TE Connectivity

Product Change Notification: PCN-21-124961

PCN Date: 28-DEC-21

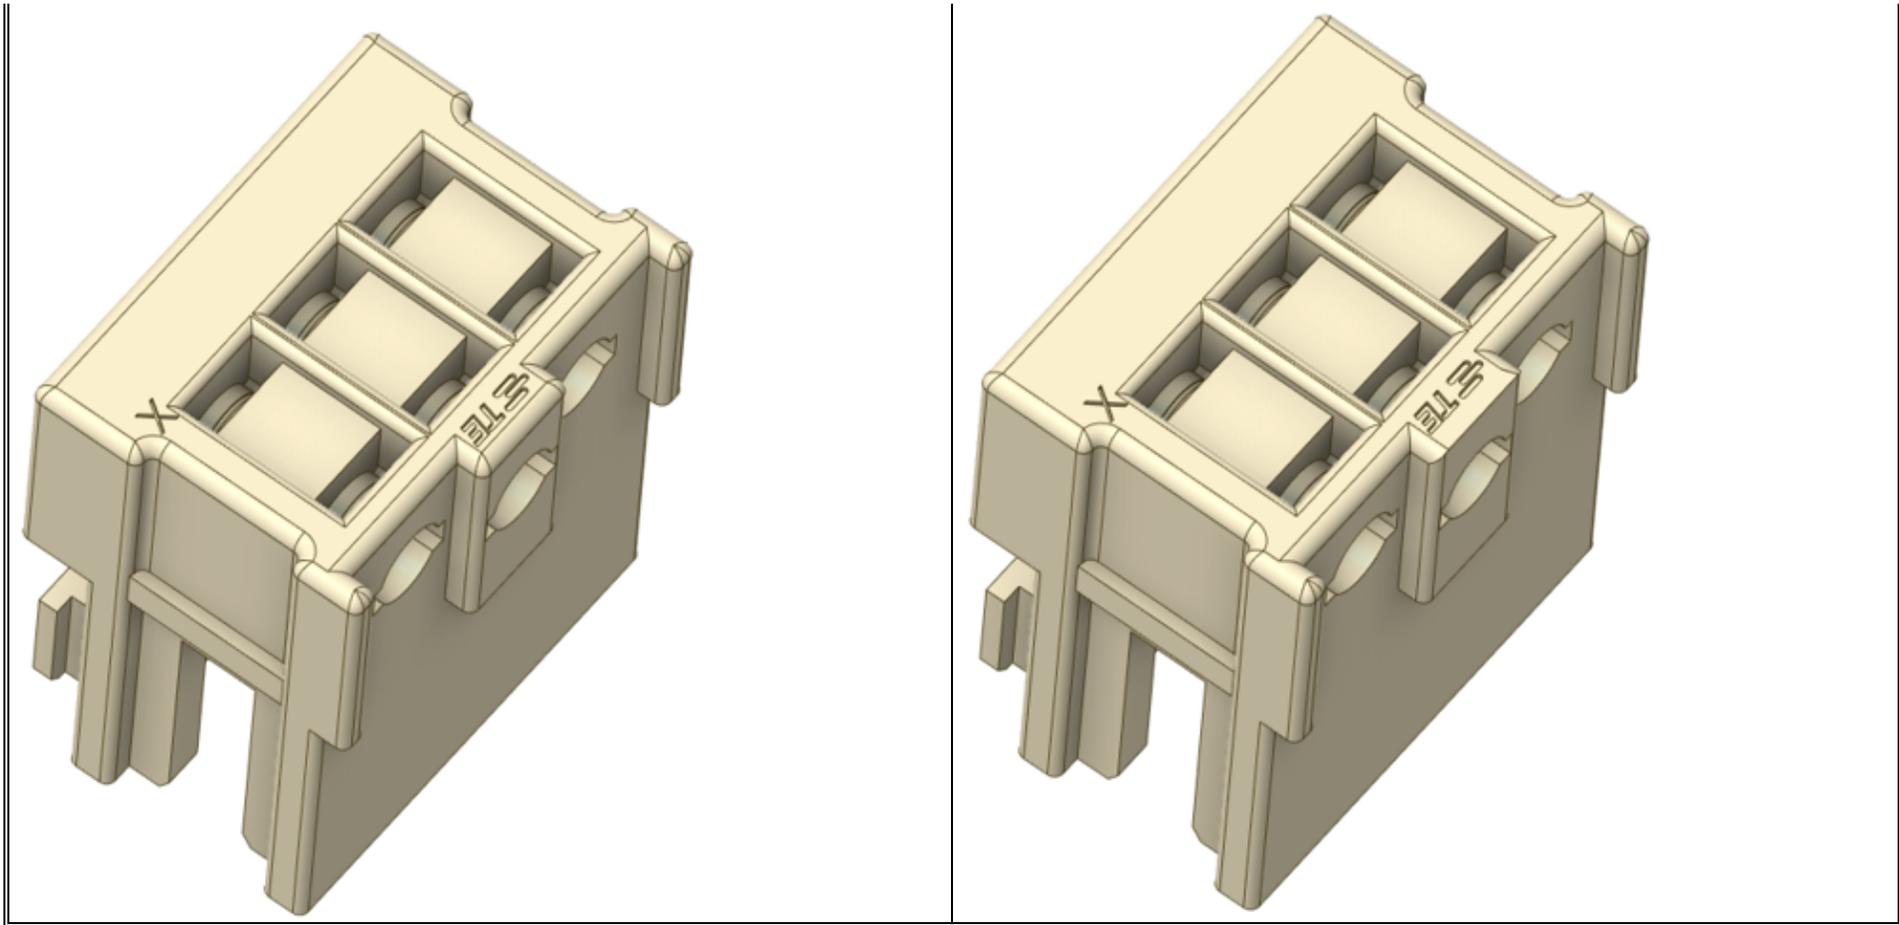
Before: with a radius in the edge After: Remove a place of radius to improve locking force, especially when pull out at

Before: with a radius in the edge After: Remove a place of radius to improve locking force, especially when pull out at 45 degree direction.

Have radius. Easy to pull out at 45 degree direction.

Remove the radius. Improve the locking force.
